5 COMMONWEALTH PARADE, MANLY

PROJECT
THREE STOREY RESIDENTIAL FLAT BUILDING
WITH BASEMENT CAR PARK AT:

5 COMMONWEALTH PDE,
MANLY, NSW

S4.55 LIST OF AMENDMENTS:

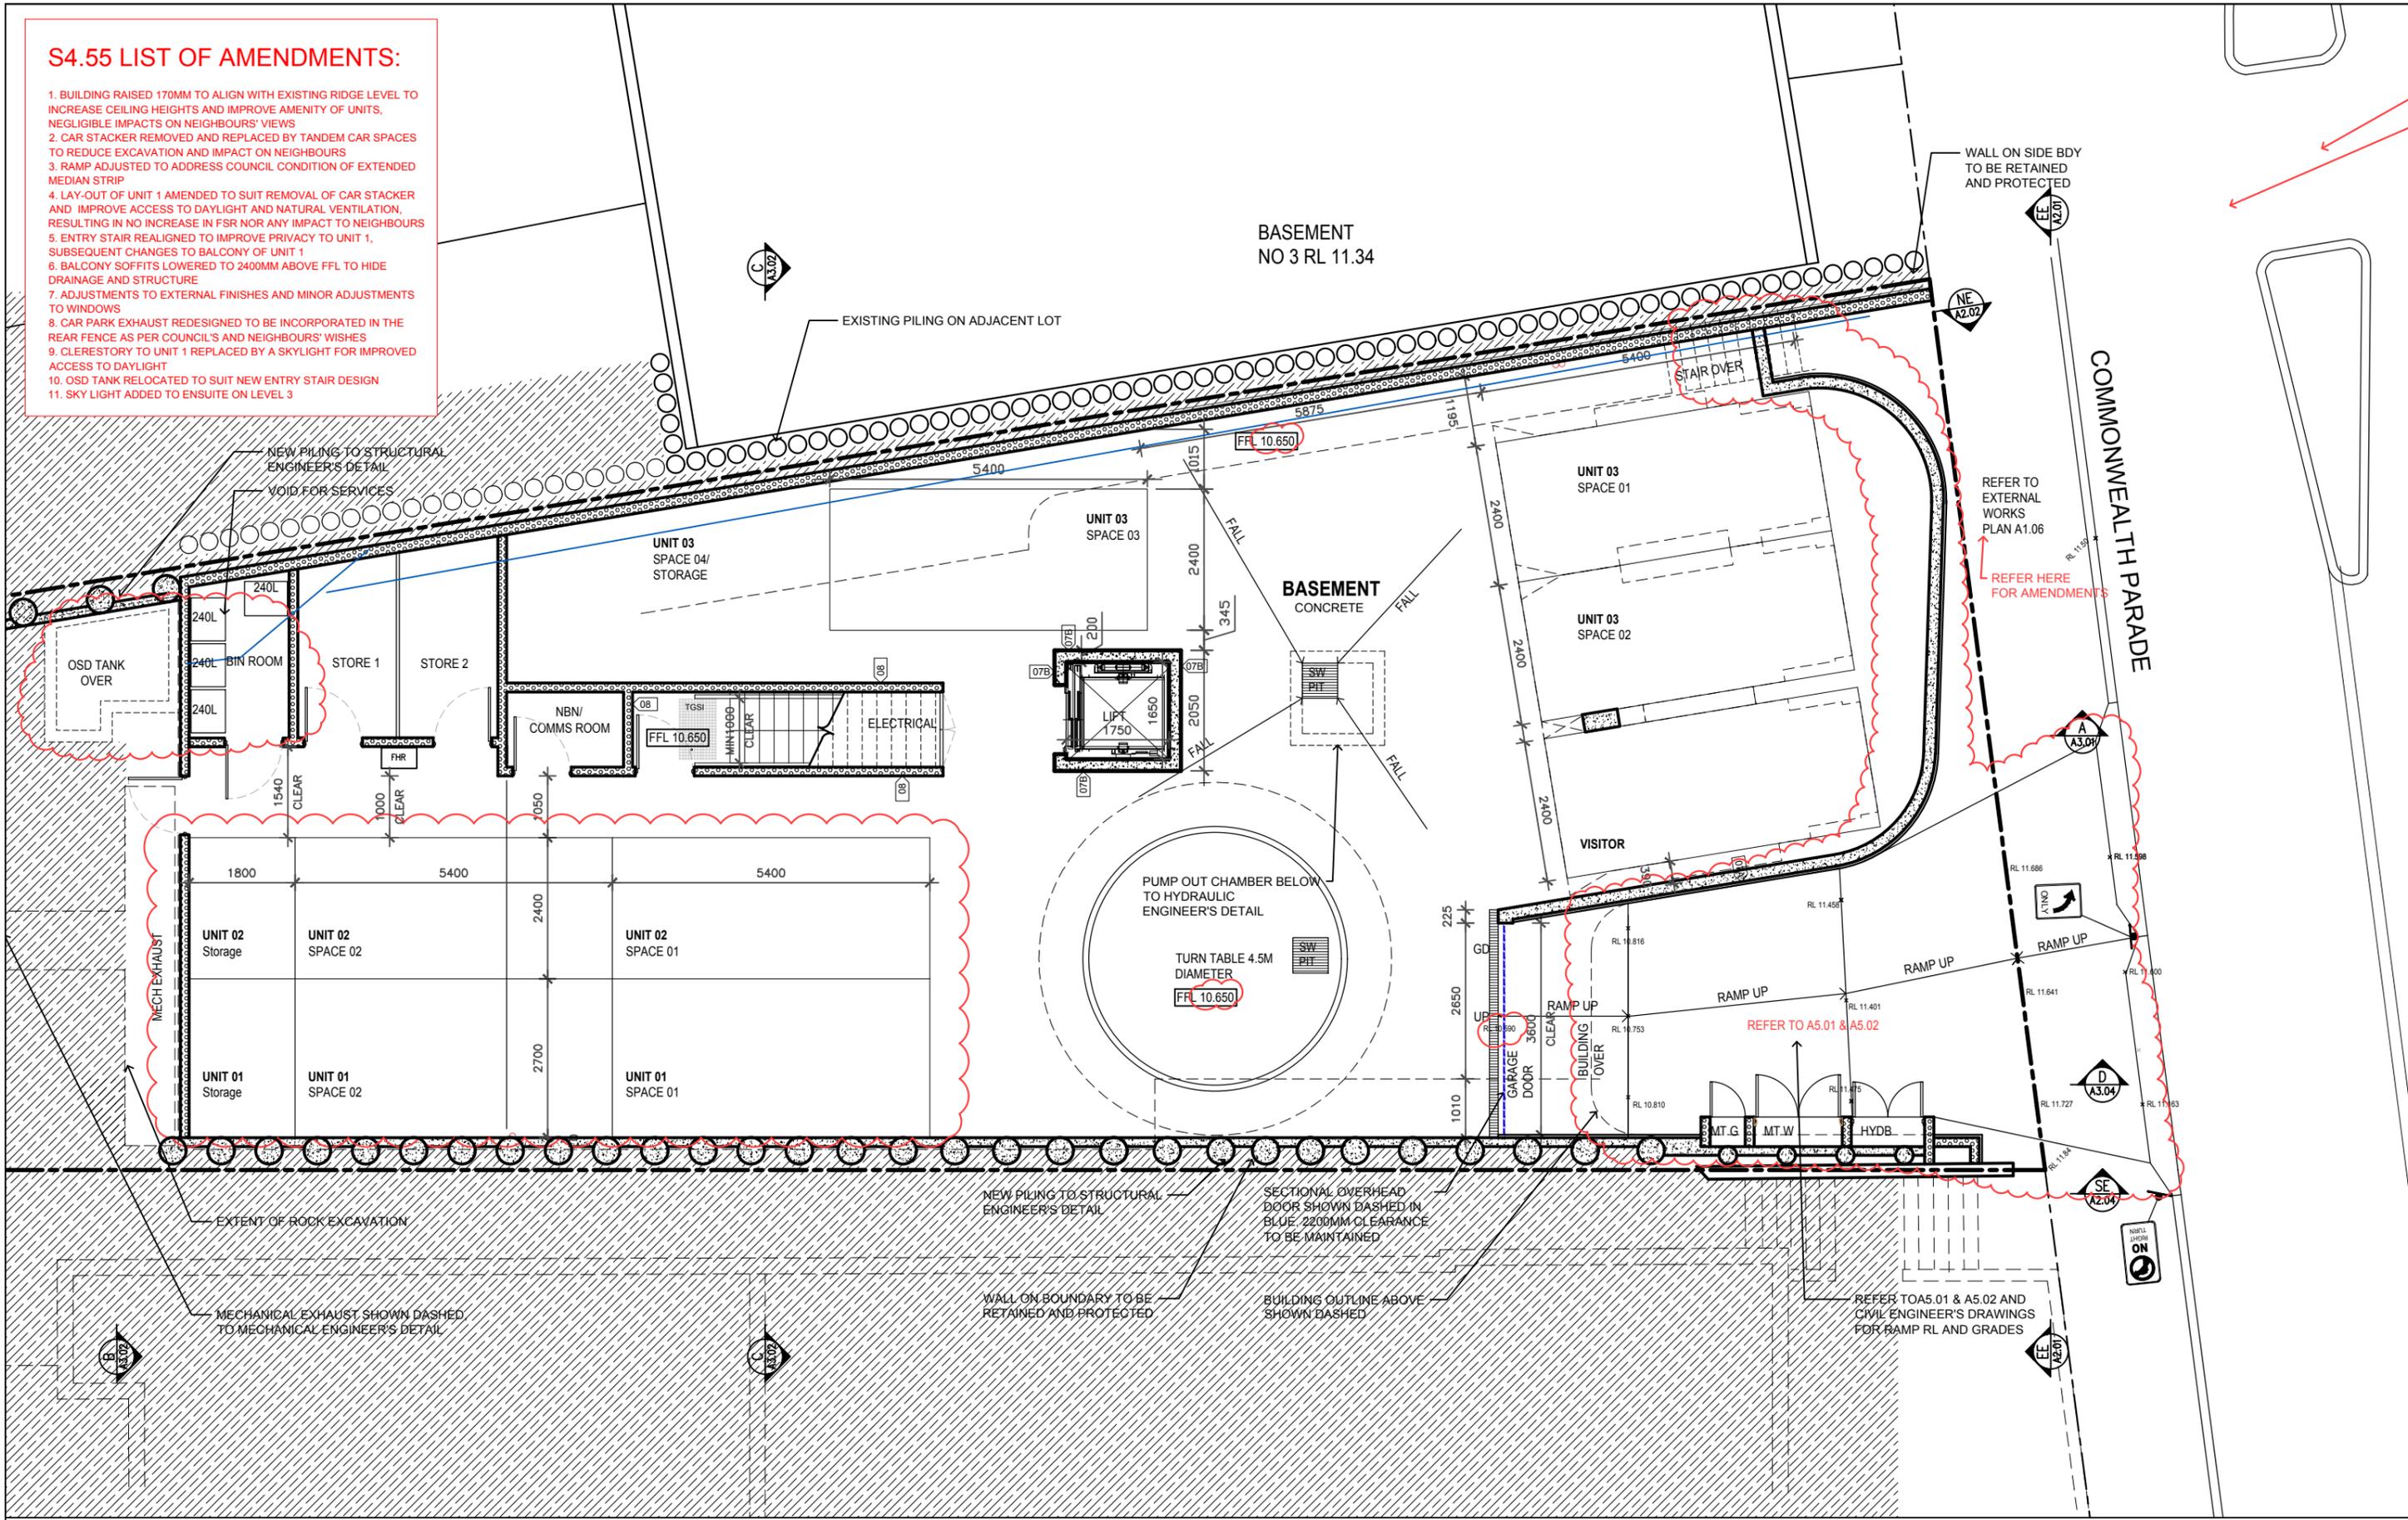
1. BUILDING RAISED 170MM TO ALIGN WITH EXISTING RIDGE LEVEL TO INCREASE CEILING HEIGHTS AND IMPROVE AMENITY OF UNITS, NEGLIGIBLE IMPACTS ON NEIGHBOURS' VIEWS

2. CAR STACKER REMOVED AND REPLACED BY TANDEM CAR SPACES TO REDUCE EXCAVATION AND IMPACT ON NEIGHBOURS
3. RAMP ADJUSTED TO ADDRESS COUNCIL CONDITION OF EXTENDED MEDIAN STRIP

4. LAY-OUT OF UNIT 1 AMENDED TO SUIT REMOVAL OF CAR STACKER AND IMPROVE ACCESS TO DAYLIGHT AND NATURAL VENTILATION, RESULTING IN NO INCREASE IN FSR NOR ANY IMPACT TO NEIGHBOURS

5. ENTRY STAIR REALIGNED TO IMPROVE PRIVACY TO UNIT 1, SUBSEQUENT CHANGES TO BALCONY OF UNIT 1
6. BALCONY SOFFITS LOWERED TO 2400MM ABOVE FFL TO HIDE DRAINAGE AND STRUCTURE

7. ADJUSTMENTS TO EXTERNAL FINISHES AND MINOR ADJUSTMENTS TO WINDOWS
8. CAR PARK EXHAUST REDESIGNED TO BE INCORPORATED IN THE REAR FENCE AS PER COUNCIL'S AND NEIGHBOURS' WISHES

9. CLERESTORY TO UNIT 1 REPLACED BY A SKYLIGHT FOR IMPROVED ACCESS TO DAYLIGHT
10. OSD TANK RELOCATED TO SUIT NEW ENTRY STAIR DESIGN
11. SKY LIGHT ADDED TO ENSUITE ON LEVEL 3

DRAWING TITLE
BASEMENT PLAN
 PROJECT
CPM
 SCALE
1:100 @A3
 STATUS
S4.55
 NUMBER
A1.00
 REVISION
s4.55

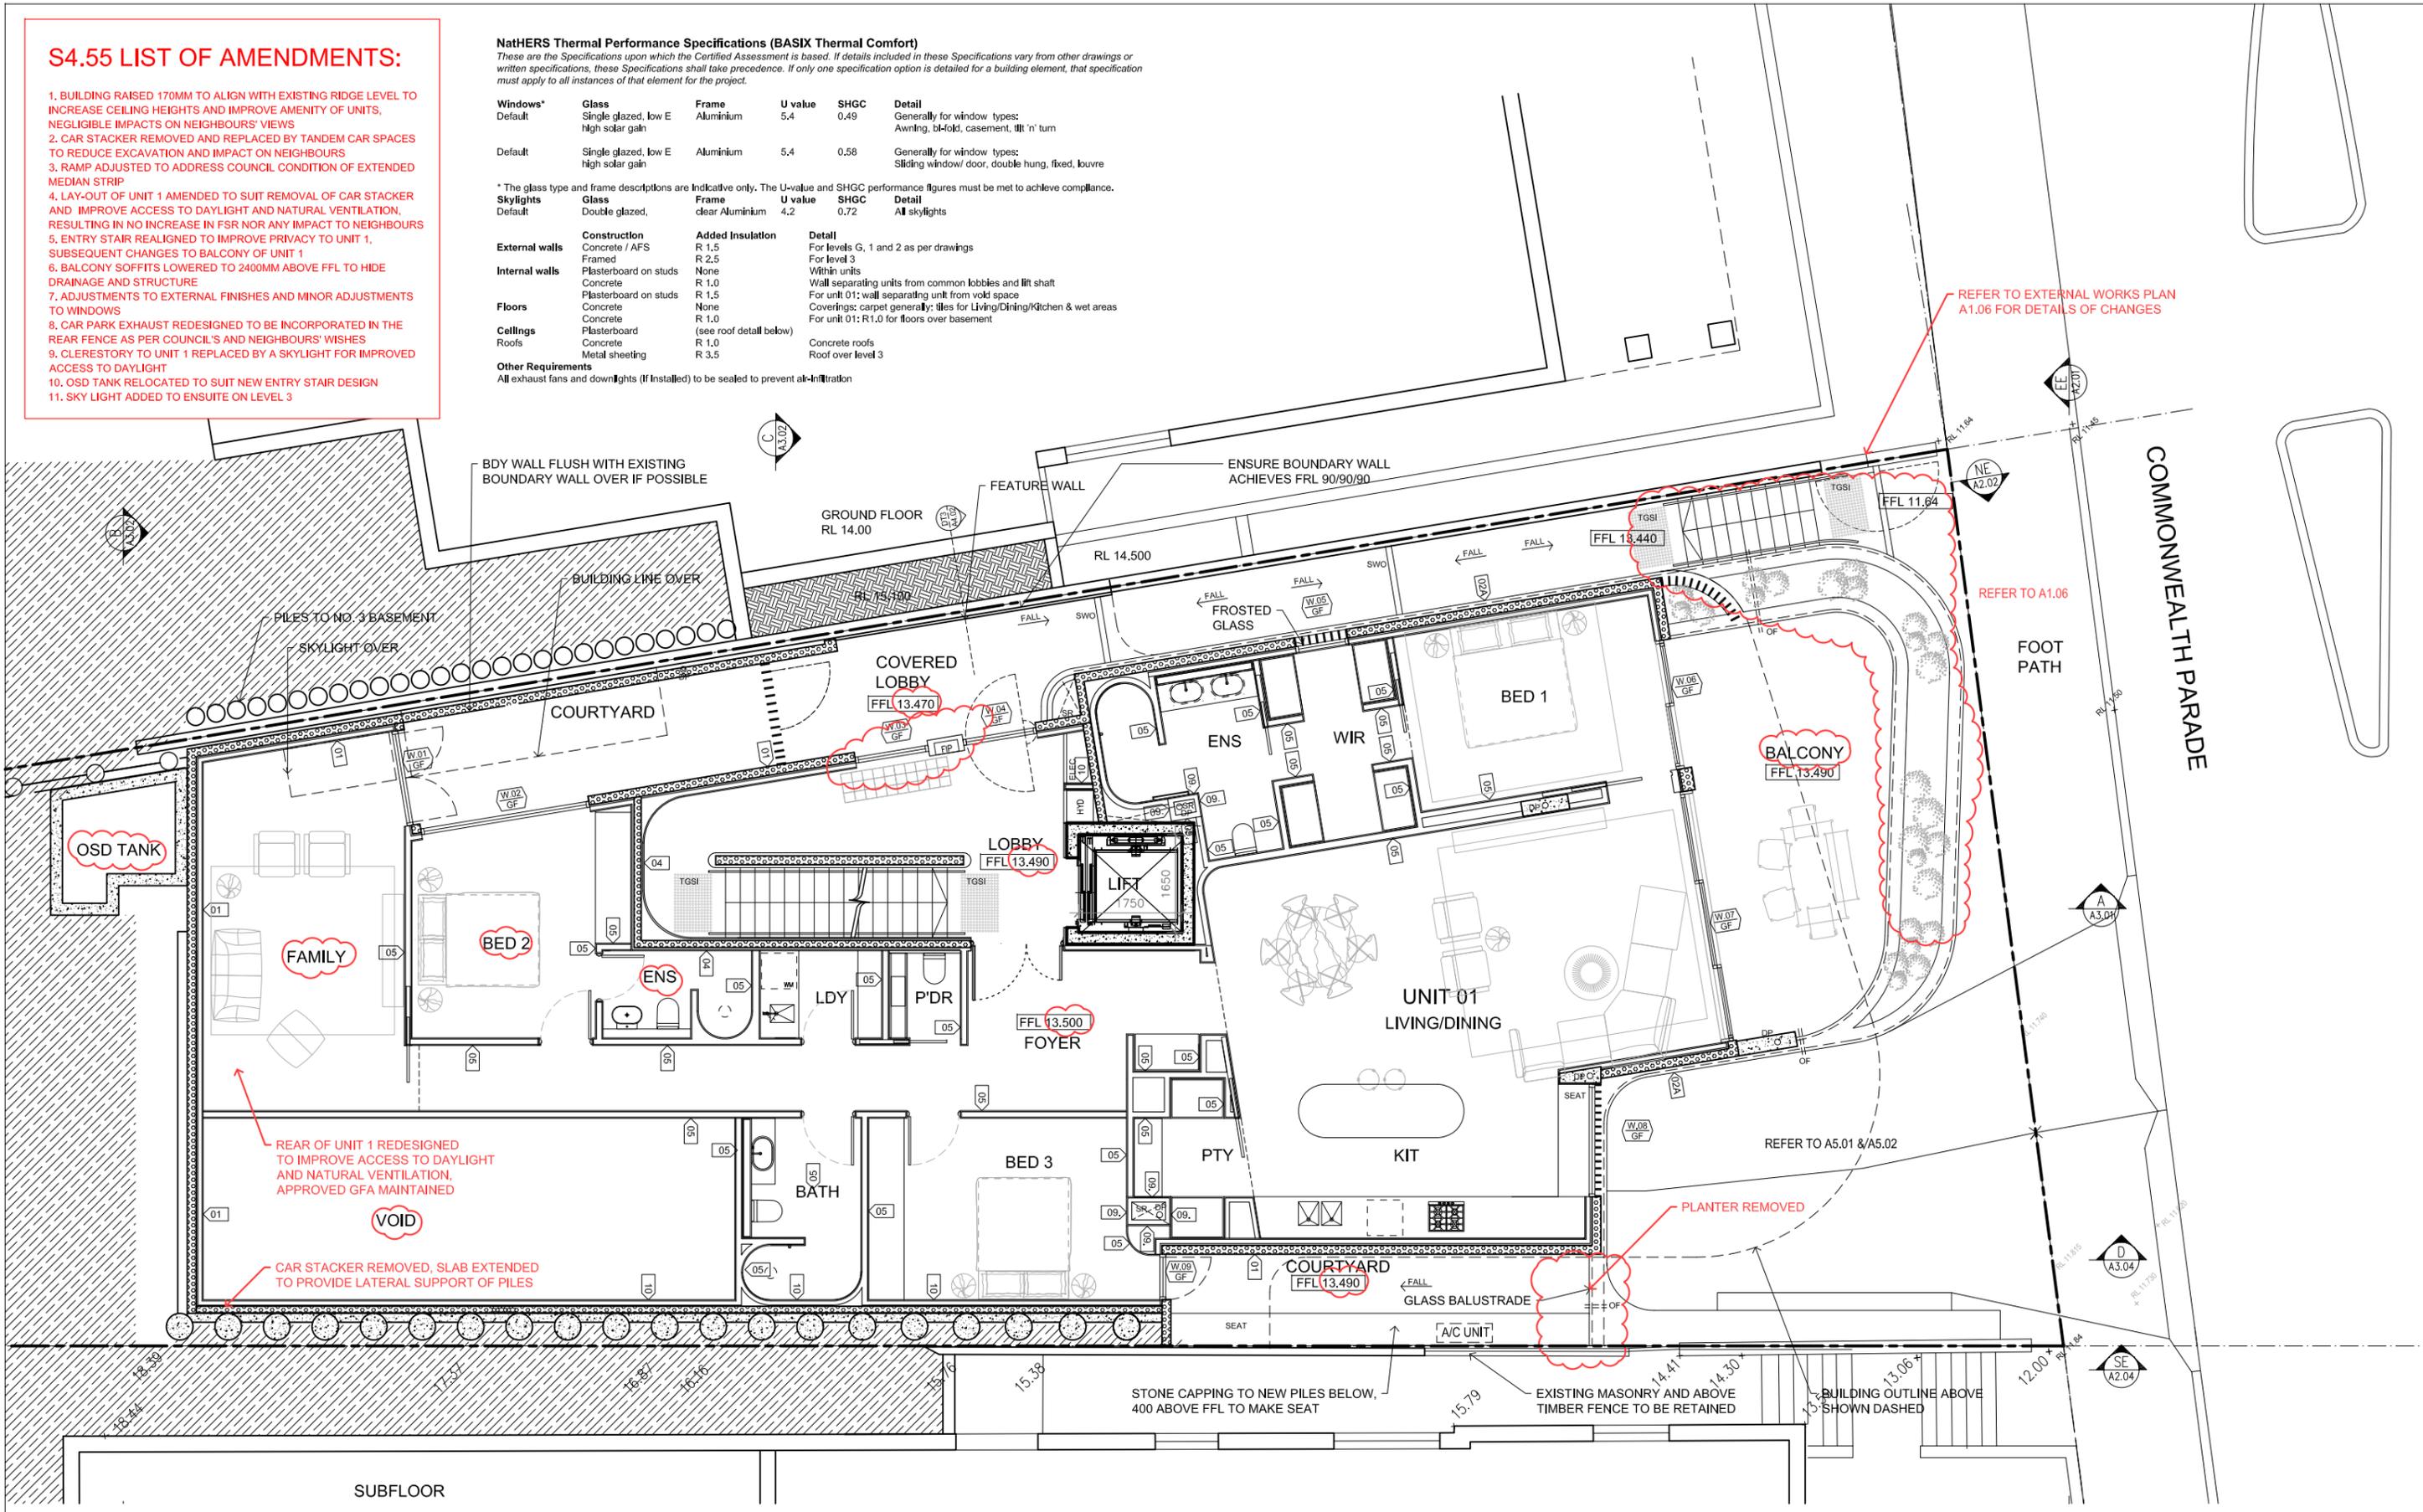
- BUILDING RAISED 170MM TO ALIGN WITH EXISTING RIDGE LEVEL TO INCREASE CEILING HEIGHTS AND IMPROVE AMENITY OF UNITS, NEGLIGIBLE IMPACTS ON NEIGHBOURS' VIEWS

- CAR STACKER REMOVED AND REPLACED BY TANDEM CAR SPACES TO REDUCE EXCAVATION AND IMPACT ON NEIGHBOURS
- RAMP ADJUSTED TO ADDRESS COUNCIL CONDITION OF EXTENDED MEDIAN STRIP

- LAY-OUT OF UNIT 1 AMENDED TO SUIT REMOVAL OF CAR STACKER AND IMPROVE ACCESS TO DAYLIGHT AND NATURAL VENTILATION, RESULTING IN NO INCREASE IN FSR NOR ANY IMPACT TO NEIGHBOURS

- ENTRY STAIR REALIGNED TO IMPROVE PRIVACY TO UNIT 1, SUBSEQUENT CHANGES TO BALCONY OF UNIT 1
- BALCONY SOFFITS LOWERED TO 2400MM ABOVE FFL TO HIDE DRAINAGE AND STRUCTURE

- ADJUSTMENTS TO EXTERNAL FINISHES AND MINOR ADJUSTMENTS TO WINDOWS
- CAR PARK EXHAUST REDESIGNED TO BE INCORPORATED IN THE REAR FENCE AS PER COUNCIL'S AND NEIGHBOURS' WISHES

- CLERESTORY TO UNIT 1 REPLACED BY A SKYLIGHT FOR IMPROVED ACCESS TO DAYLIGHT
- OSD TANK RELOCATED TO SUIT NEW ENTRY STAIR DESIGN
- SKY LIGHT ADDED TO ENSUITE ON LEVEL 3
